DEPARTMENT OF PLANNING  
STAFF REPORT

**CMPT 2009-0012, Town of Leesburg Lower Sycolin Pump Station**

**SUBJECT: CMPT 2009-0012, Town of Leesburg Lower Sycolin Pump Station**

COMMISSION PERMIT PLAT  
LOWER SYCOLIN CREEK  
PUMP STATION

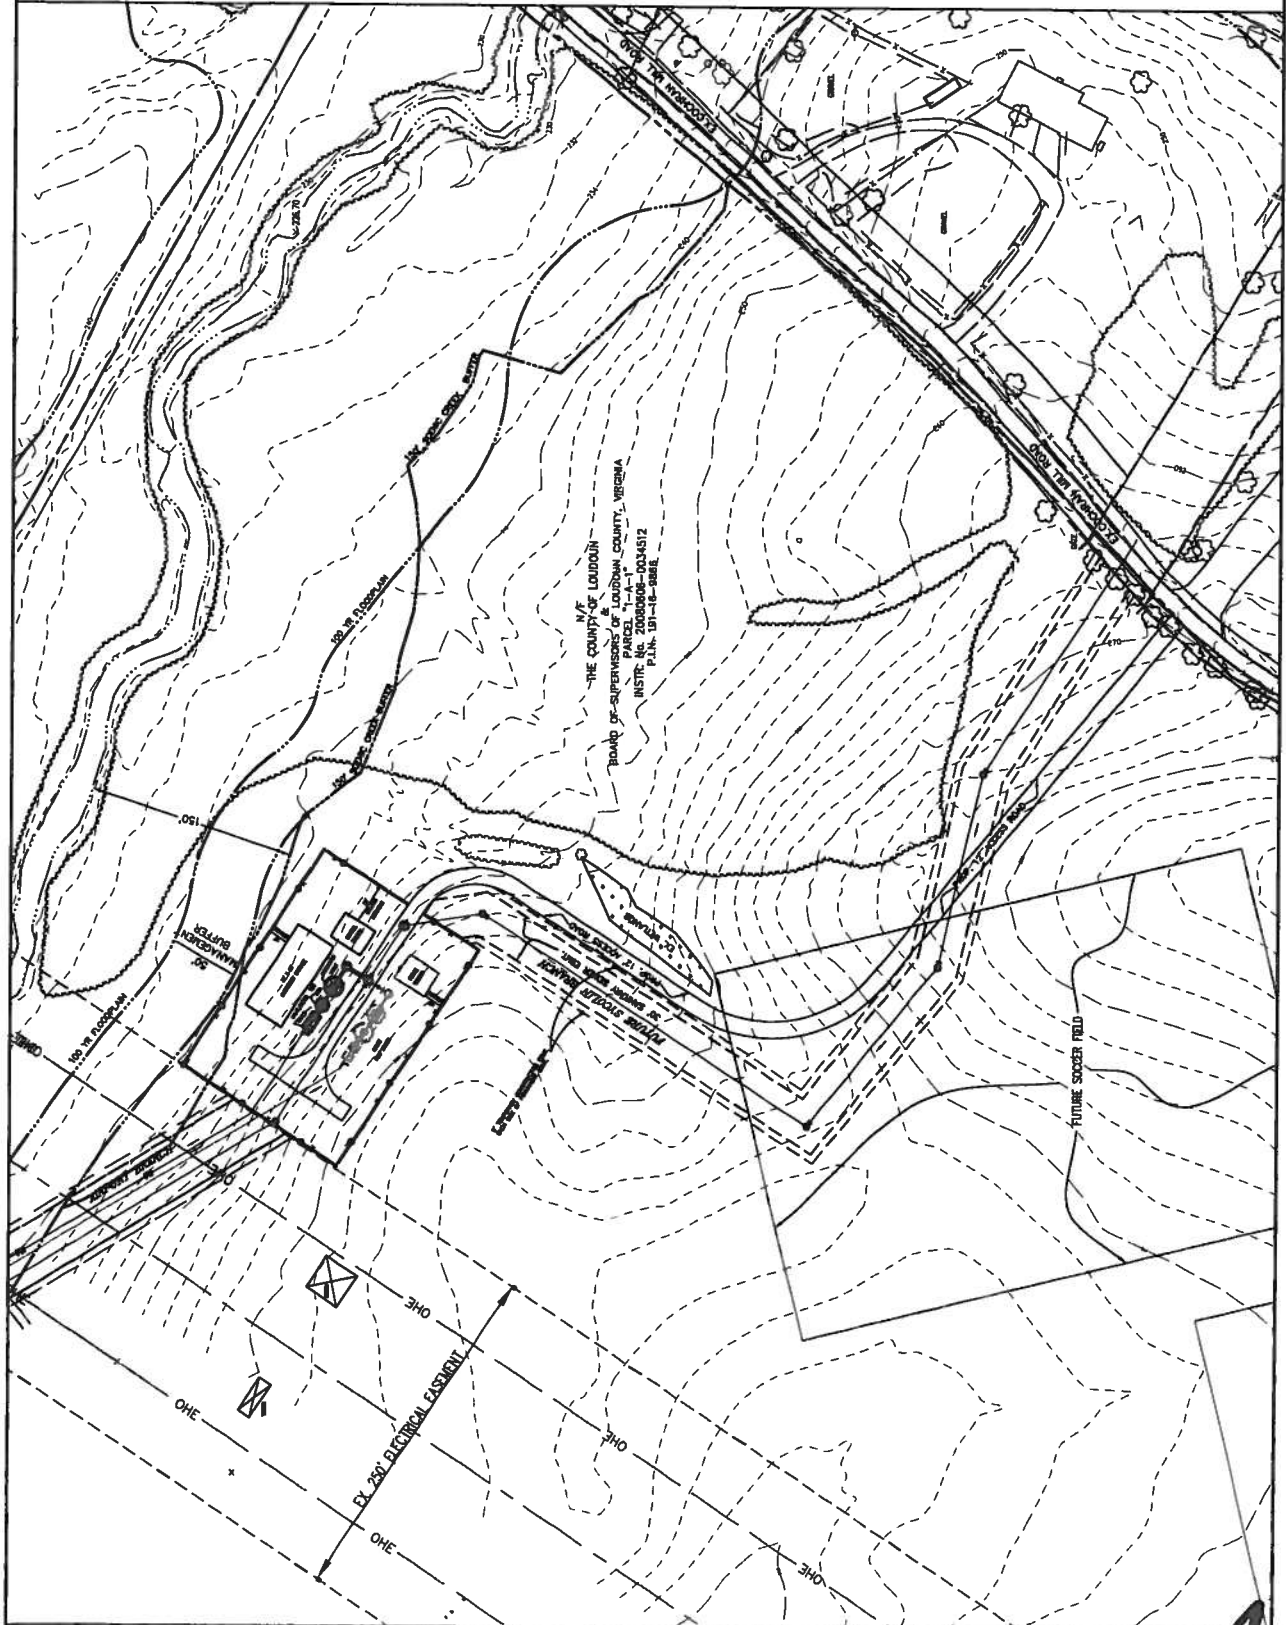
***Staff recommends revising the submitted plats to include moderately steep slopes based upon the 2-foot topography. Staff encourages locating development outside of moderately steep slope (between 15 and 25 percent) areas to the greatest extent possible to minimize potential effects of soil erosion and sedimentation. If the impacts to moderately steep slopes cannot be avoided, staff recommends the applicant use best management practices to mitigate the impacts of the proposed development.***

Comment #1: In the Applicants narrative it's stated that future ball fields shown on the approved special exception will be avoided to the extent possible. However, the commission permit plat shows the proposed access road and a section of sewer impacting one of the future ball fields. PRCS request that the applicant work closely with PRCS staff to determine the least impact to this area.

4. Access shall be provided by a privately owned and maintained travelway, which shall be either a private access easement that complies with the FSM, or a private lane. The plat shall note and provide for the maintenance of the easement or lane. Section 5-621(C) states that public utilities may be accessed by a private access easement. The plat does not provide the disposition of the "proposed 12' access road". State the disposition of the access road and how it will be maintained. In addition, the access road cuts through a future soccer field; remove the access road from the soccer field.

9. County records indicate that there are very steep and moderately steep slopes throughout the site. Show the limits of the steep slopes to ensure that there is no impact, and if there is, any development must meet the performance standards. Sanitary sewer lines are permitted in very and moderately steep slopes, in accordance with Sections 5-1508(E) and (F). If either slope is impacted, demonstrate compliance with 5-1508(E)(7)(a) through (I) and 5-1508(F)(1) through (3).
10. Prior to the issuance of a zoning permit, the Zoning Administrator must be provided sufficient information to ensure the performance standards are met per §5-1509.

Applicant Response: *In order not to impact the proposed soccer fields, access to the pump station will be provided using the road network for the park as shown on the plat.*

Access to the subject site will be provided using the internal road network for the park in order to avoid impact to the planned athletic fields, off of Sycolin Road. The proposed access route is shown on the plat. Emergency access will be provided to Cochran Mill Road utilizing an emergency access roadway to Bolen Park.

9. A slope analysis using field-run 2-foot topography was completed. Moderate and steep slope are identified on the plat. Details will be provided in the Site Plan for the proposed development.
10. Comment Acknowledged.
